Product/Process Change Notification (PCN)

Customer: Newark

Date: August 21, 2015

A1203ELHLT-T	A1203LLHLX-T	A1205LLHLT-T
A1203ELHLX-T	A1205ELHLT-T	A1205LLHLX-T
A1203LLHLT-T	A1205ELHLX-T	
<i>Including all finishing suffix variations of the sales roots listed</i>

Package Body Overlay

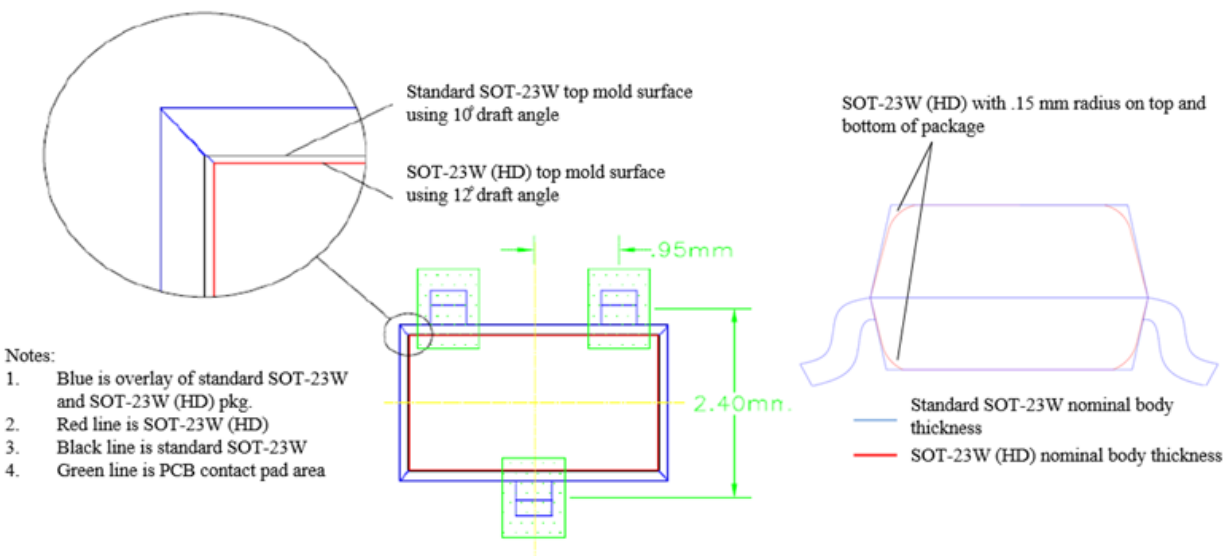
Standard SOT23W vs. SOT-23W (HD)

Standard SOT-23W	SOT-23W (HD)
	Nominal	Nominal
Radii	NA	0.15
Draft angle	10°	12°
